DEVELOPMENT APPLICATION NO: DA19/0875

URBIS RESPONSE TO PENRITH CITY COUNCIL REQUEST FOR ADDITIONAL INFORMATION – 27TH APRIL 2020

Response to RFI Relating to Visual Impacts

NEPEAN GARDENS, WALLACIA, NSW

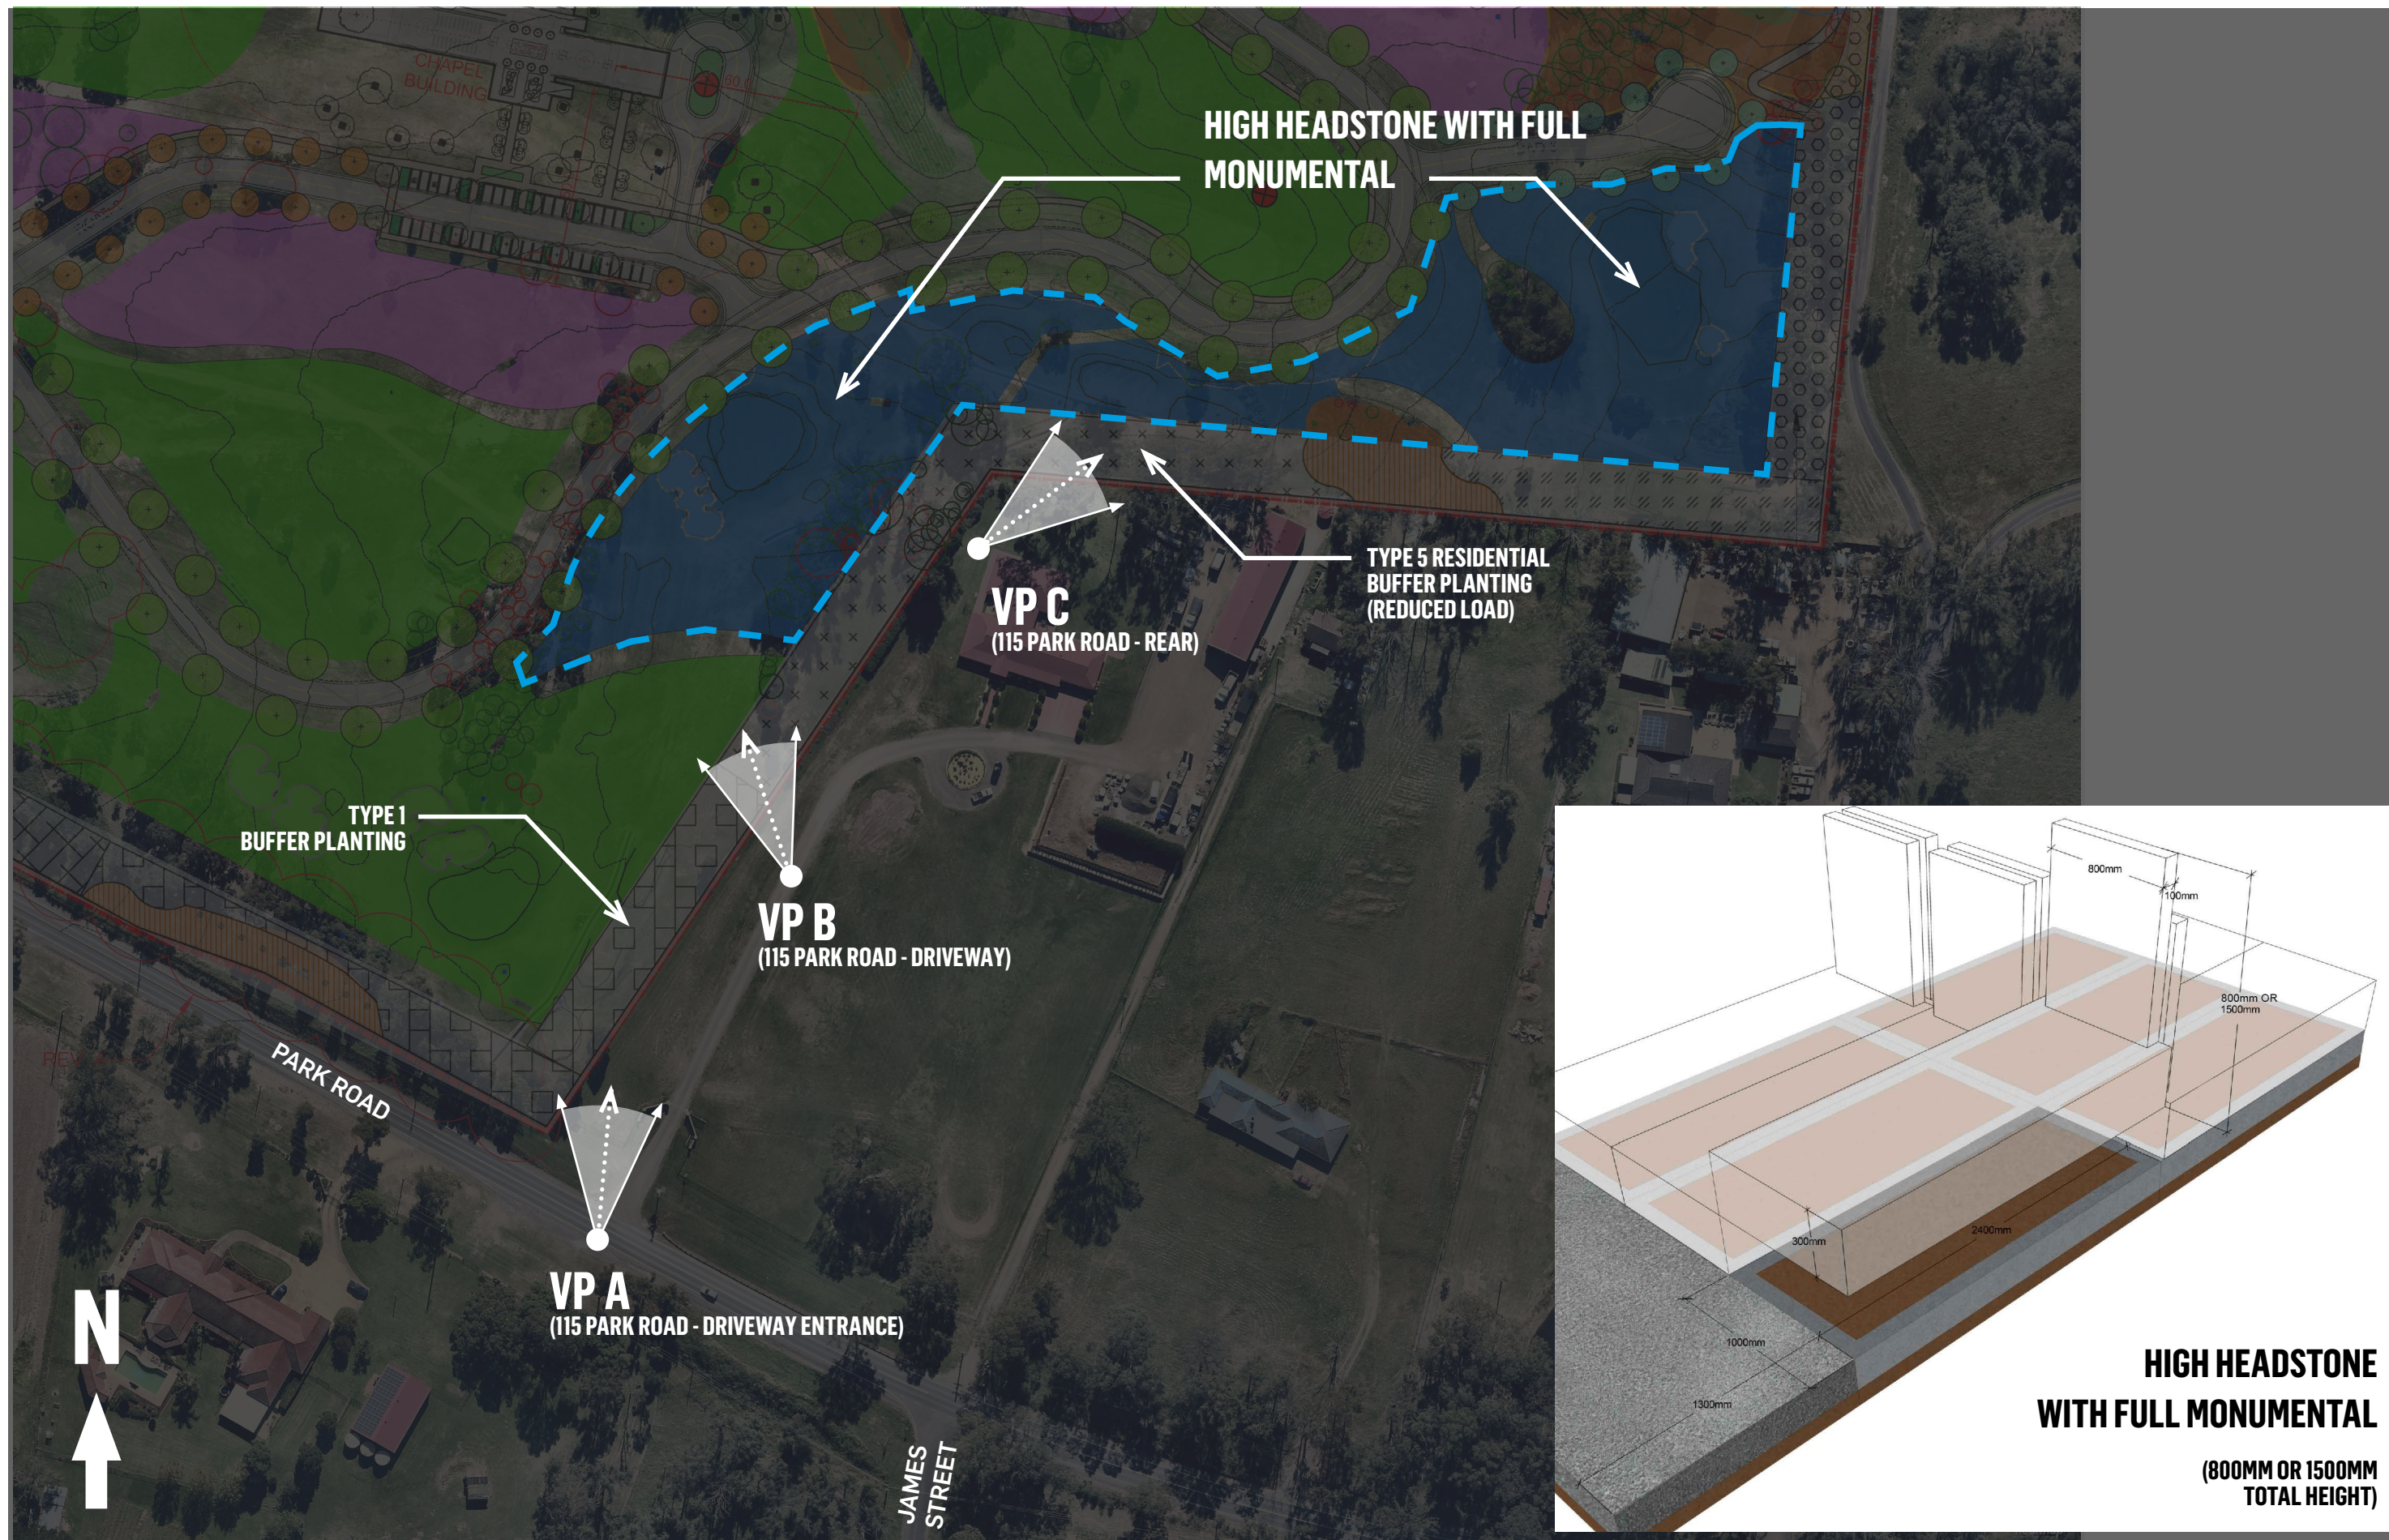
(h) The proposal for Type 3 - 1.5m high memorial head stones is likely to impact poorly on views from neighboring rural residential properties. A response is requested as to why memorial headstones should not be limited in height to 600-800mm, so as to be less visible. The impact of the proposal for Type 4 - Full monumental installations needs to be assessed and in this regard, further detail is to be provided as to the allowable dimensions and locations for this typology. A view analysis or montage may be required.

The proposed Type 3 headstones are 1.5 m in height, 800 mm wide and 100mm deep (refer to DWG NO: VP_MAP).

Type 4 involves a headstone as per the Type 3 with a low slab placed over the entire surface area of an individual plot, 2.4 m long, 1 m wide and 300mm high (refer to DWG NO: VP_MAP).

Representative viewpoints for the preparation of the 3D simulations were selected based on a range of typical viewing scenarios from Park Road (VP A) and from within the 115 Park Road property (VP B and VP C) (refer to DWG NO: VP_MAP).
